RESPONSE TO NRC 6/28/77 REQUEST FOR ADDL INFO  
ON INSERVICE INSPECTION PROGRAM: W/ATTACHED  
ENCLOSURES 1 thru 5 ..... DOCKET NO. 50-272  
RECEIVED WITH LETTER DATED 10/11/77  
ACCESSION # 773000214

ADDITIONAL INFORMATION FOR  
REVIEW OF PROPOSED INSERVICE INSPECTION AND TESTING PROGRAMS  
SALEM NUCLEAR GENERATING STATION

DETAILED EXPLANATION OF  
EXCEPTIONS TO THE ASME BOILER AND PRESSURE VESSEL CODE SECTION XI  
FOR THE SALEM UNIT NO. 1 INSERVICE INSPECTION PROGRAM

Item B5.6 Category B-L-1

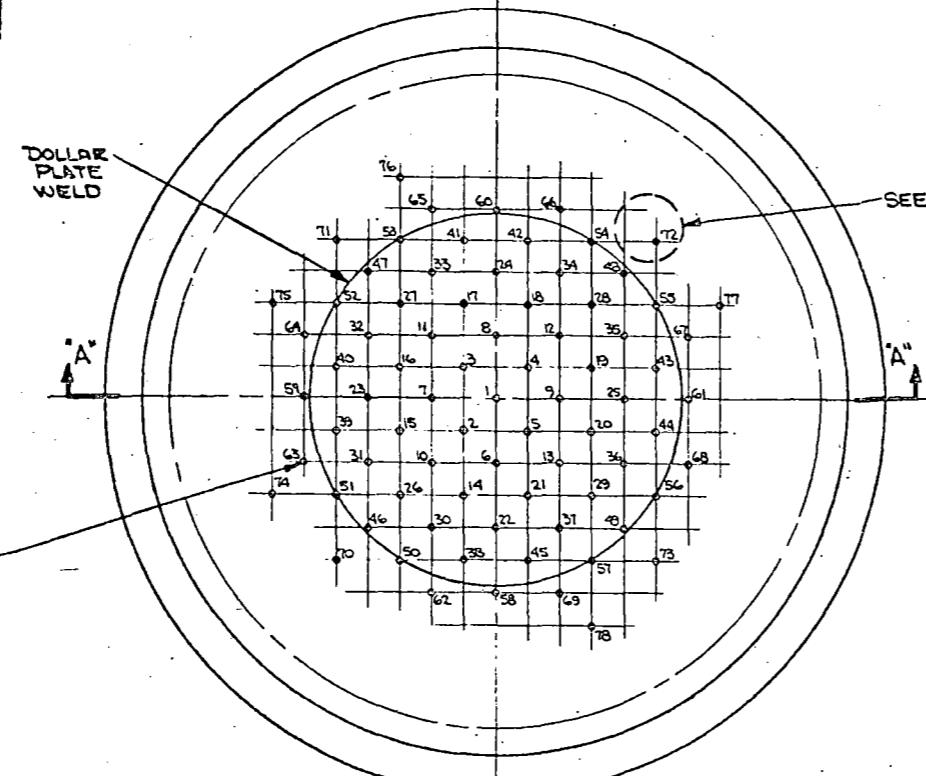
Volumetric examination will not be performed on these welds. A surface examination will be performed as well as a visual examination for leaks required by Section XI. These welds are identified as 11-PMP-1, 12-PMP-1, 13-PMP-1 and 14-PMP-1 in the examination plan.

The Reactor Coolant Pump casings are made of cast stainless steel which can not be penetrated by ultrasonic examination techniques. Also, acceptable radiographs cannot be obtained due to fogging of the film caused by long exposure time coupled with background radiation from the pump casing. Radiography will be considered as new techniques are developed to examine these welds in the future.

INLET NOZZLE CONFIGURATION	
N.2.1 UNIT	
SALEM NUCLEAR GEN. STATION	
PUBLIC SERVICE ELECTRIC AND GAS COMPANY	
ENGINEERING DEPARTMENT	
NEWARK, N.J.	
DRAWN <u>J.R.</u>	CHECKED _____
DATE _____	EXAMINED _____
AUTH. _____	APPROVED <u>J.H. Jake</u>
SK-8-15-77

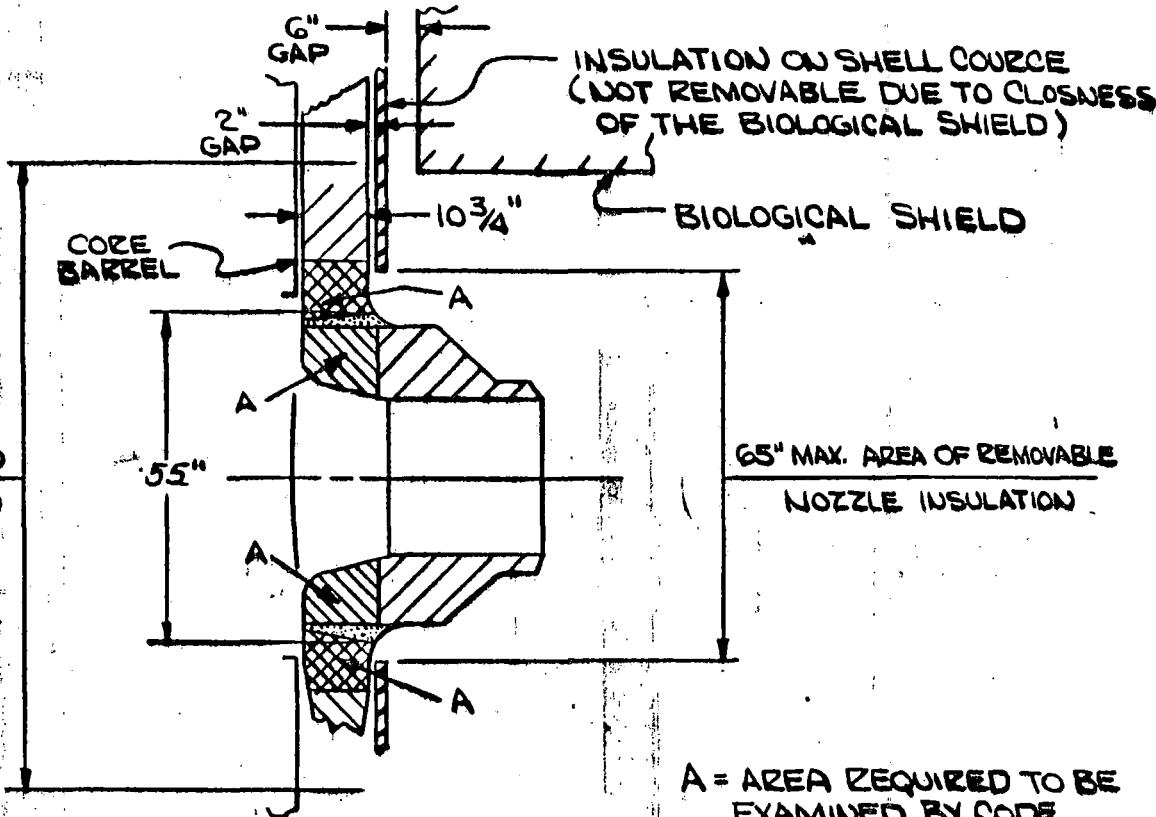
Volumetric examination will not be performed when the Core Barrel is in place due to inaccessibility. The examinations will be performed when the core barrel is removed during the inspection interval. These welds are identified as 27.5-1110-1, 27.5-RPV-1120-1, 27.5-RPV-1130-1 and 27.5-RPV-1140-1 in the examination plan.

As indicated in PSE&G Sketch No. 8-15-77 attached, the Core Barrel covers the weld area when it is in place. Since all weld examinations are performed from the inside surface using an mechanized inspection device, these welds are inaccessible at this time. Examinations cannot be performed from the outside surface due to the area being covered by insulation on the shell of the weld and the configuration of the weld joint on the nozzle side of the weld. The insulation on the shell portion of the reactor vessel is not designed for removability and to remove it would require the cutting away of the insulation support rings from the vessel.
